AGENDA
CITY OF CEDAR FALLS, IOWA
PLANNING AND ZONING COMMISSION MEETING
WEDNESDAY, AUGUST 28, 2024
5:30 PM AT CITY HALL, 220 CLAY STREET

TO: Planning and Zoning Commission
FROM: Thom Weintraut, AICP, Planner III
 Ben Claypool, Civil Engineer II, PhD., PE.
DATE: August 28, 2024
SUBJECT: HWY-1 District Site Plan for Golden China

REQUEST: HWY-1 District Site plan approval for construction of a new restaurant, Golden China, on Lot 4 of Pinnacle Prairie Commercial South, Phase V (Case # SP24-004)
PETITIONER: Dan Levi, Levi Architecture; Darren Fang, LLC, Owner; Monica Smith, Robinson Engineering Company
LOCATION: 1150 Brandilynn Boulevard and east of Prairie Parkway.

Revised North Elevation

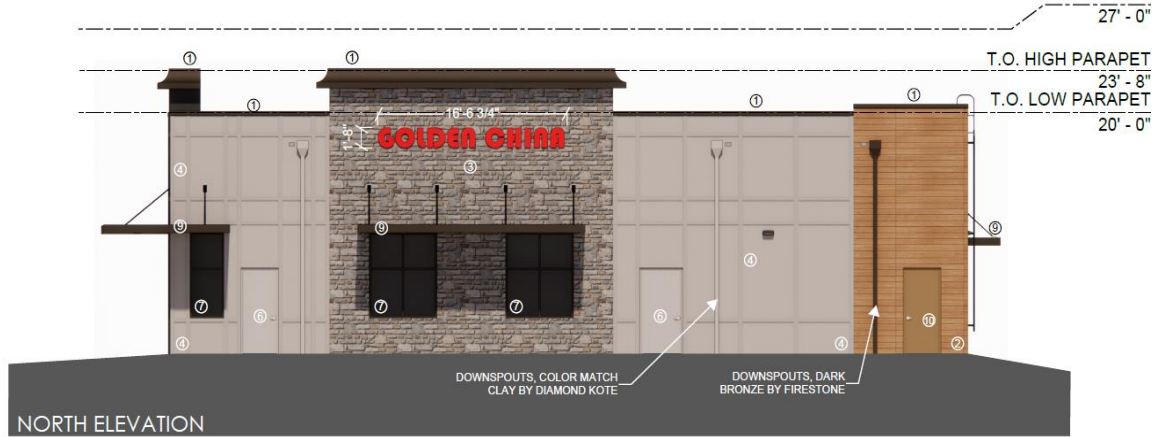
Due to topographical constraints, the applicant could not provide a more direct route to the entrance from Brandilynn Boulevard and meet the ADA requirements. While not ideal, staff finds that due to the topographical constraints, this route is acceptable.

The applicant has added two pairs of windows with spandrel glass and a canopy to the Brandilynn façade matching the placement of the windows and canopies on the south and east sides of the building. The downspout color has changed to the board and batten siding color to blend in with the façade. The refuse area has been relocated to the parking area on the south side of the building and the screen has been removed from the location in front of the east door. The changes to the façade and the relocation of the refuse area improved the visual appearance of the building and provides a more inviting appearance from the street.

Previous Design as viewed from Brandilynn Boulevard

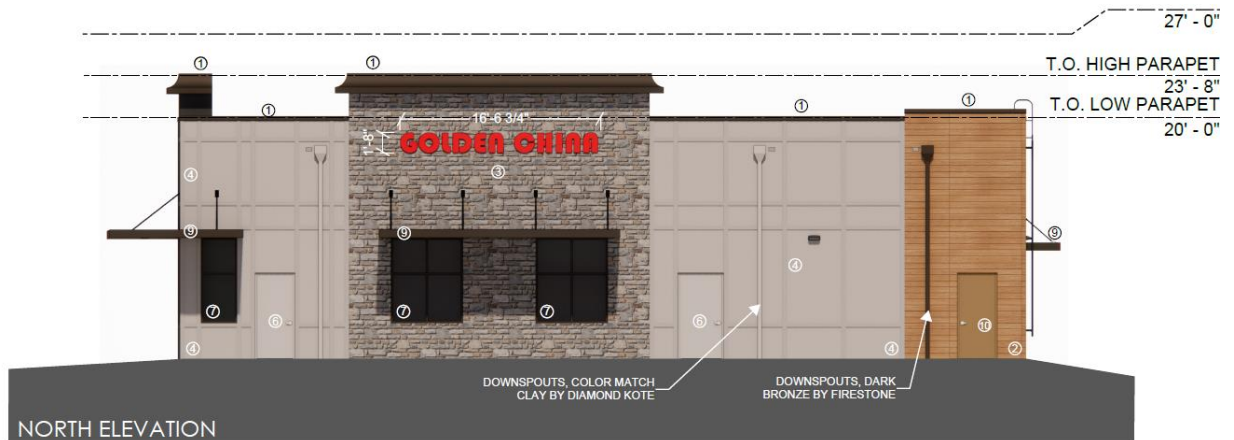
The Golden China is similar in height and scale to Veridian, the Express Clinic, and the Boulder Tap House. Veridian, Boulder Tap House, and Golden China use a “tower” to denote their primary entrances while the Express Clinic uses a higher parapet wall. The windows and doors on the front elevations of the Express Clinic, Veridian, and Boulder Tap House are similar in size, scale and proportion not only to the individual building, but to each other. *With the changes made to the street-facing façade since the last meeting, there is now some window coverage consistent with other buildings in the vicinity. While these windows are not functional with the spandrel glass, they give the impression of a front façade. De-emphasizing the more utilitarian back-of-building elements by matching paint colors of the service doors and downspouts also helps to give a better visual impression as viewed from the public street.*

On the previous design, the street-facing façade had few windows and doors, so it did not have a pattern discernible to viewers and was not consistent with other buildings in the area. On the south, west, and east-facing elevations, the placement of windows and board and batten siding create a strong vertical rhythm, while the use of the canopy on these two façades provides horizontal relief. The brackets for the awning introduce an additional rhythm to these elevations. ***Similar windows and canopy elements have been added to the street-facing façade. The windows are now well-distributed, including on the façade facing Brandilynn. With these revisions to the design, staff finds that the building meets the standard.***

SITE DEVELOPMENT PLAN

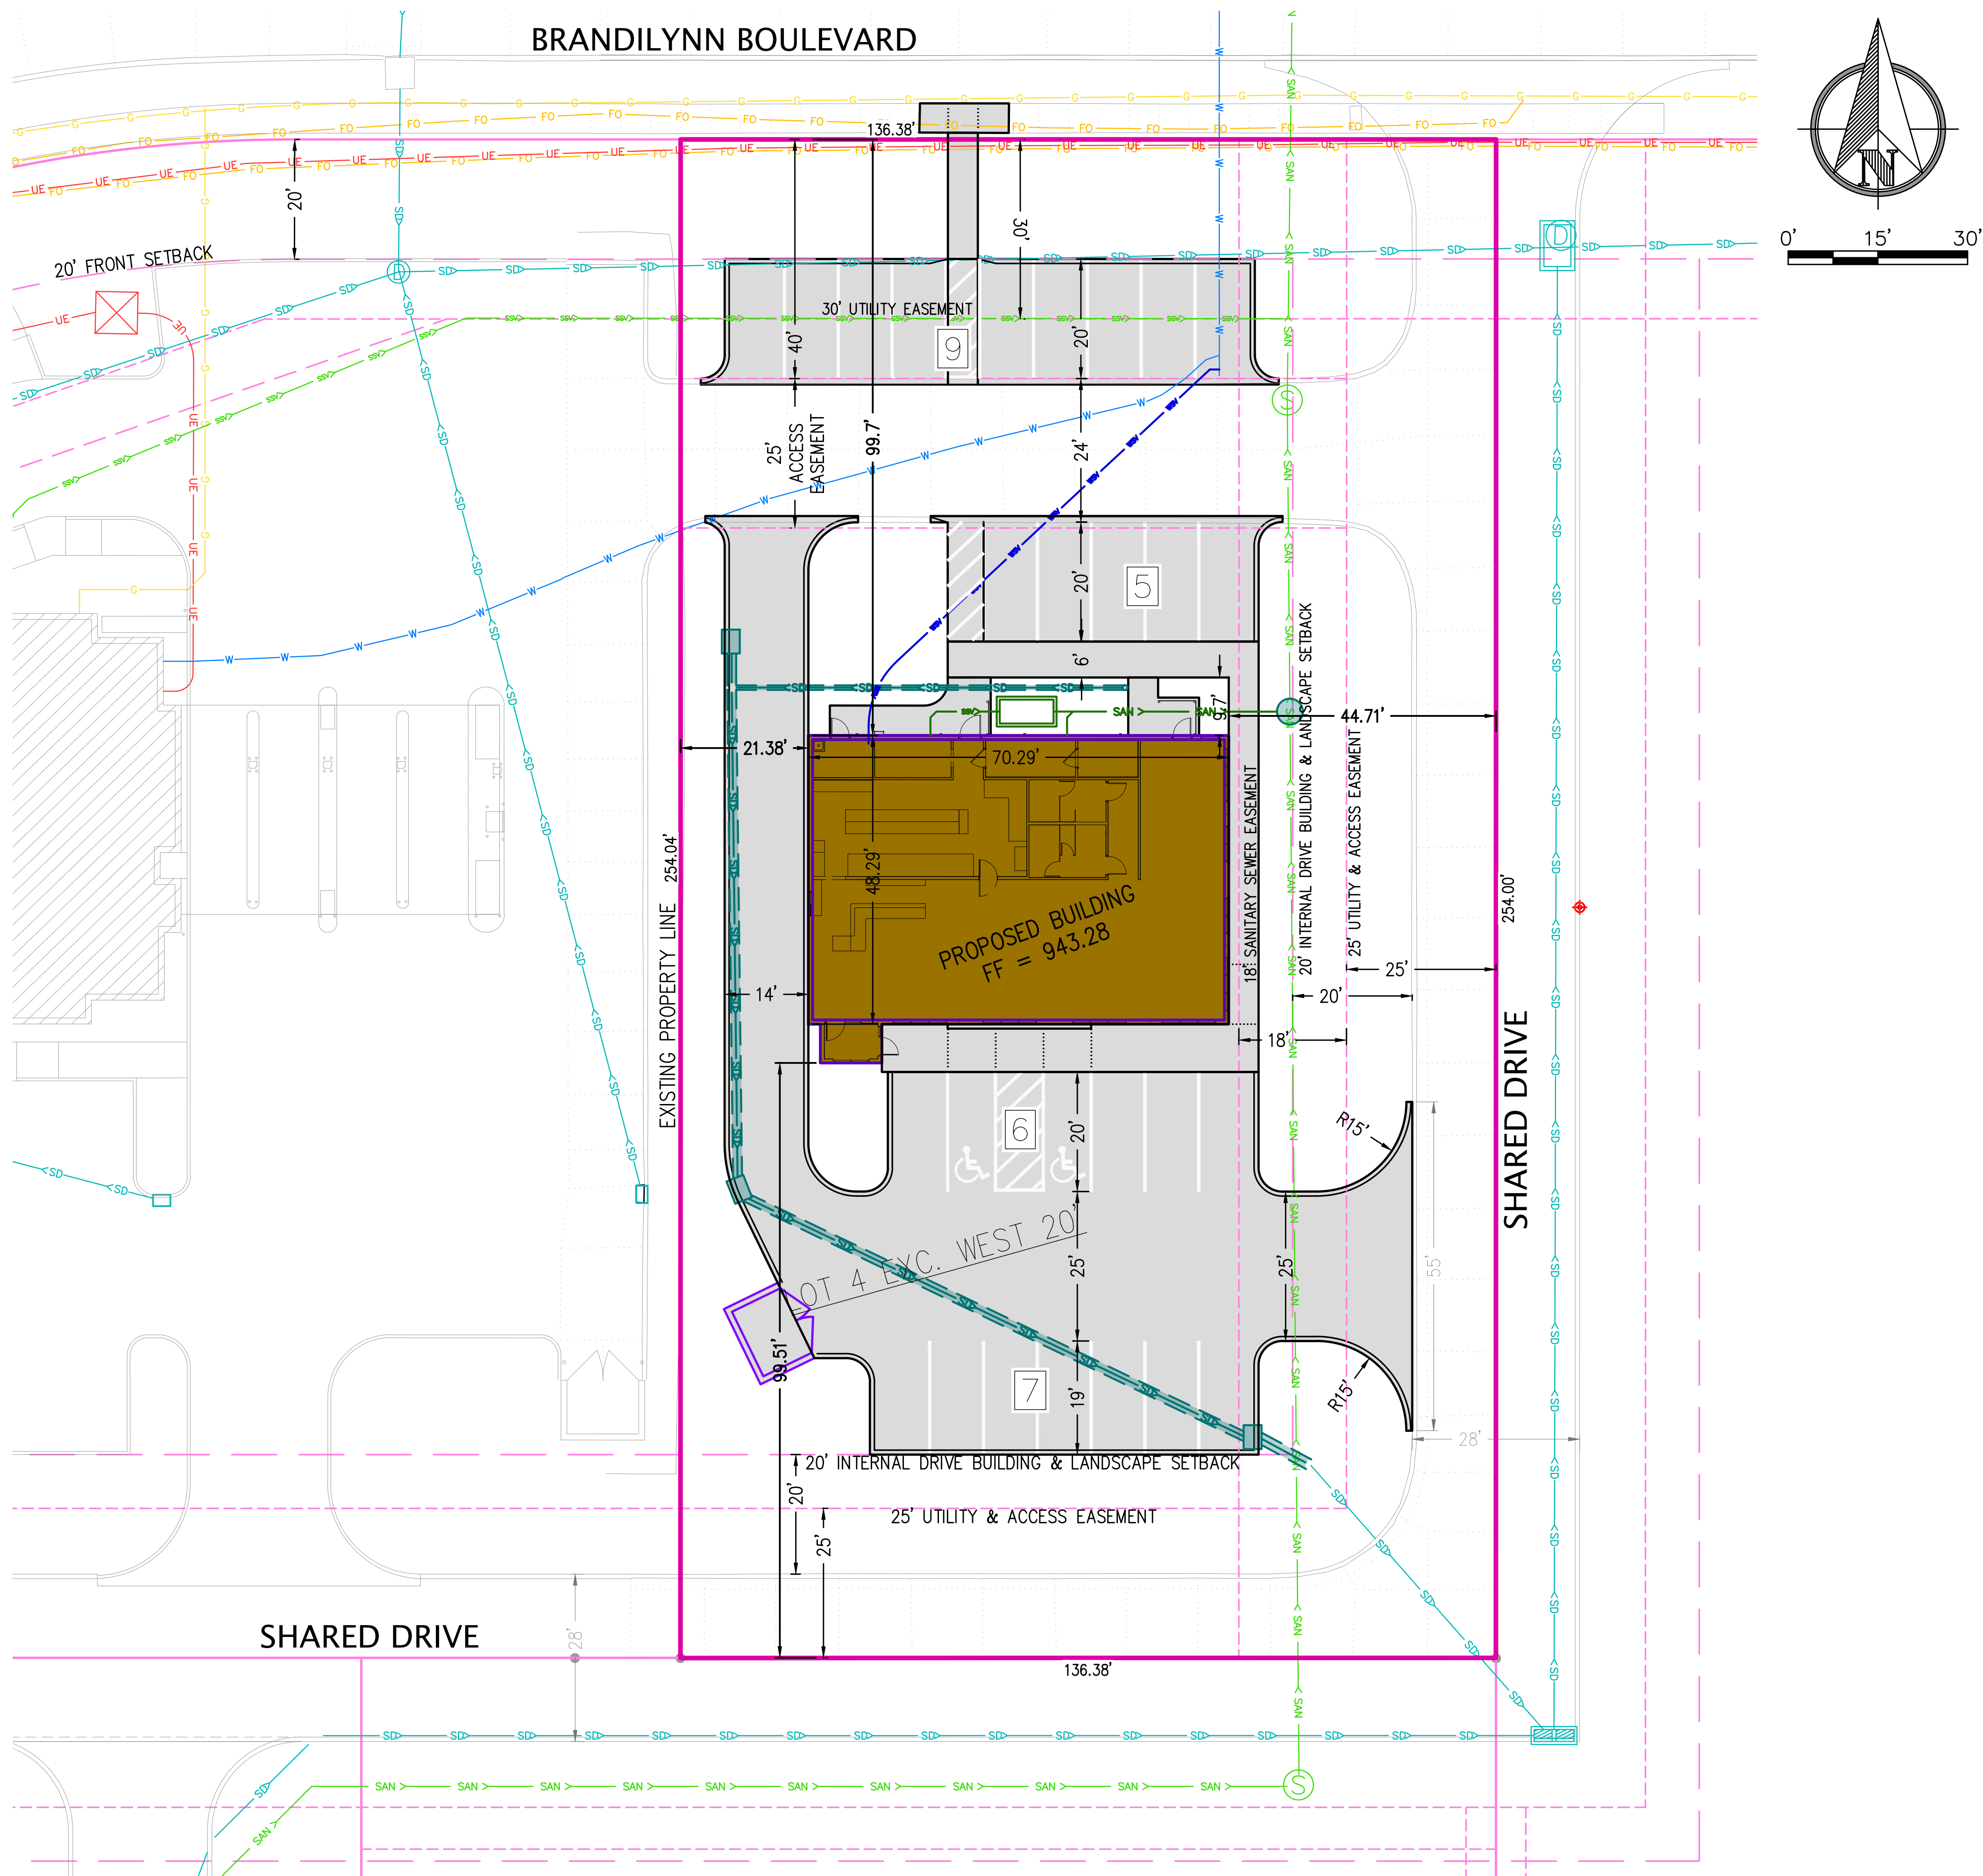
The proposed orientation of the building poses a particular challenge for pedestrian and bicycle access to the site. The sidewalk connection from Brandilynn Boulevard to the entrance of the building, leads the public to a blank wall on the rear of the building. The pedestrians are then required to walk along the rear of the building to the east side, turn and go south along the building’s eastside to the sidewalk on the south side the building, and turn west and walk to the opposite end of the building to the public entrance on the southwest corner of the building. There are no sidewalks along the private shared drive, so there is no direct or visible pedestrian access to the restaurant.

The dumpster enclosure meets City standards; however, the placement should be in a less visible location and not in the front yard and visible from Brandilynn Boulevard.

- 11) Sidewalks: There is a 5-foot-wide PCC sidewalk proposed which will connect to the Brandilynn Boulevard sidewalk. The sidewalk is circuitous in its connection from Brandilynn Boulevard. The sidewalk enters the property centered on the service-side wall of the building, and then turns east to the corner of the building, turning south to the southeast corner of the building, before turning again and crossing the entire length of the south façade to the entrance. If the building was re-oriented so the main entrance was at the northeast corner of the building facing Brandilynn Boulevard, the sidewalk could be installed along the private drive and cross the driveway and connect to the building entrance in a direct more inviting manner.

The applicant has relocated the refuse area to the southwest side of the building away from direct view from Brandilynn Boulevard. This location is less visible than the previous location. The landscape plan shows a spruce and additional native grasses around the dumpster location, which will help to screen the area from the Veridian site and the private access drive.

Due to topographical constraints, the applicant could not provide a more direct route to the customer entrance from Brandilynn Boulevard and meet the ADA requirements. While not ideal, staff finds that due to the topographical constraints, this route is acceptable.

LA.1
8/20/2024
SUBMITTAL 4

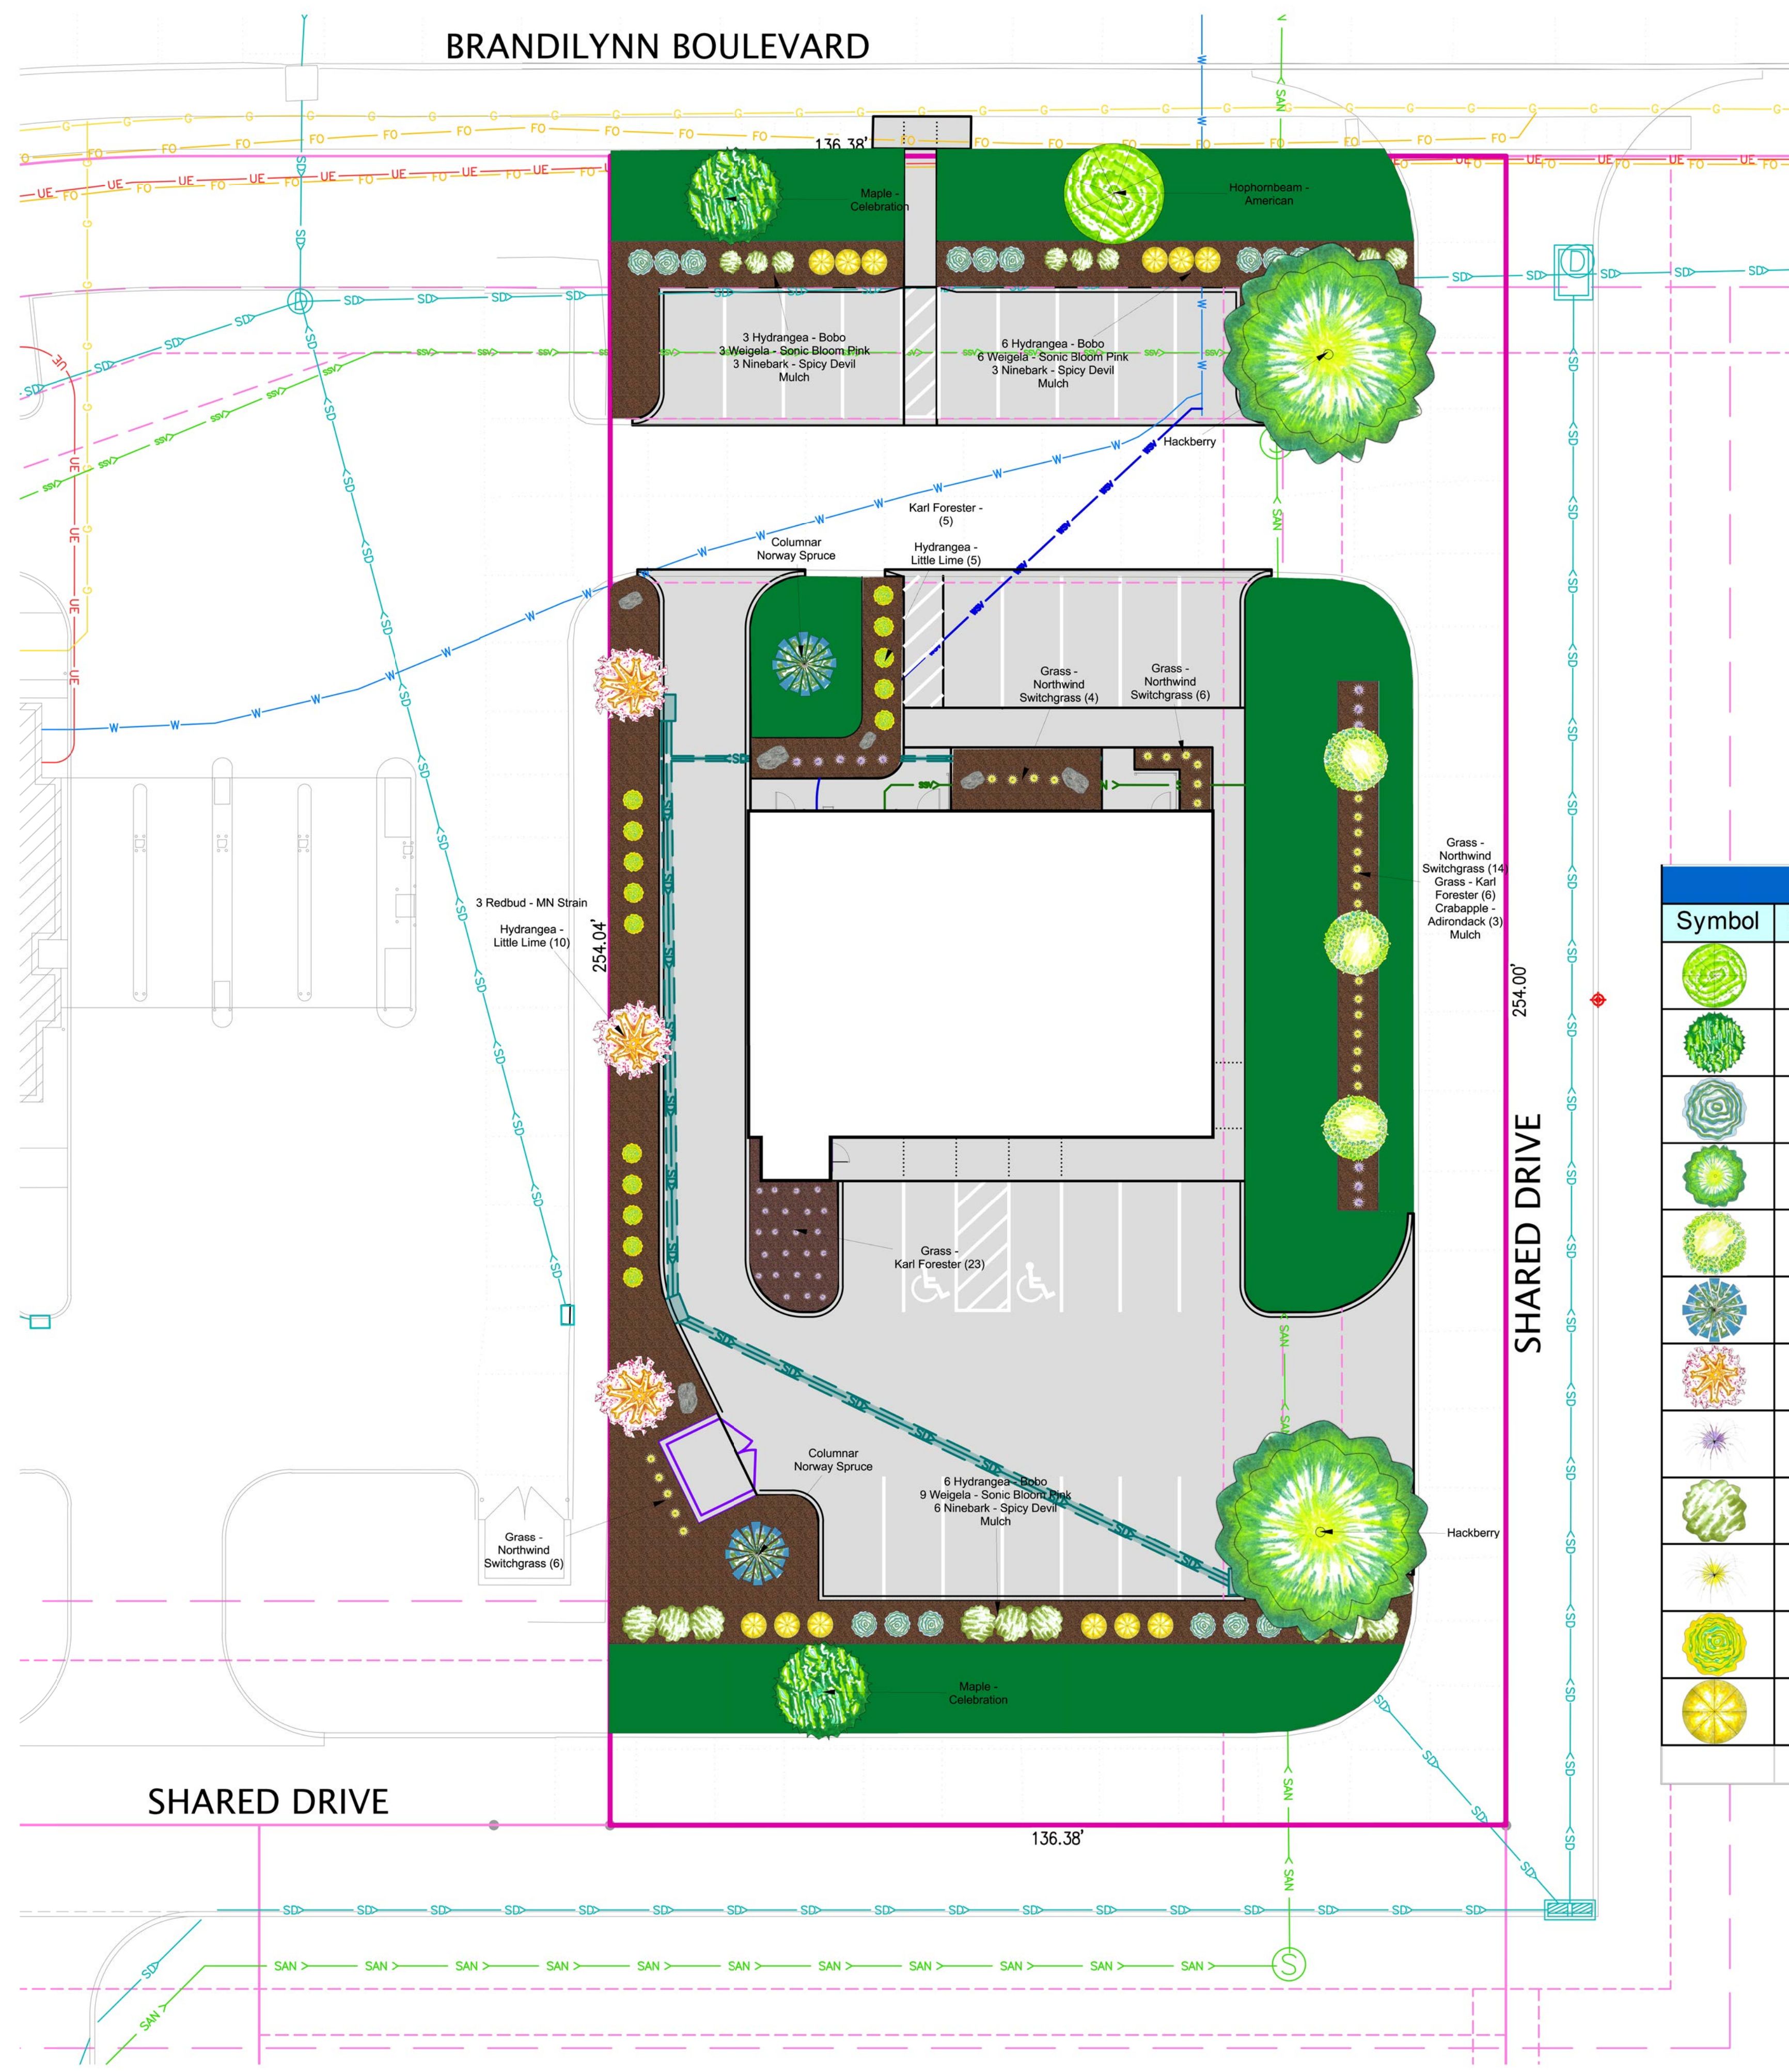
The total required site landscaping points are 681 points for the site and 320 points for street trees. The site plan shows the points for the street trees has been met and the total points for the site as 694 points; however, the landscape plan incorrectly identified the points for a 3" caliper Common Hackberry as 40 points and all 2 gallon size shrubs as 2 points. A 3" caliper Hackberry is worth 90 points, and 2 gallon shrubs are worth 5 points thus the total points landscape points equal 920 points and so the site exceeds the requirement by 239 points. Planting point details can be seen in the attached landscaping plan for review.

The landscaping plan shows the addition of a Norway Spruce along the south side of the refuse area and tall prairie grass along the west side to add screening from the private drive and adjacent property. A Norway Spruce has been added on the north side of the building in the place were the refuse area had been located along with shrubs and grasses. With the addition of the two spruces, the number of landscape points exceeds the required number of landscape points and the number of points on the plan submitted at the August 14 meeting.
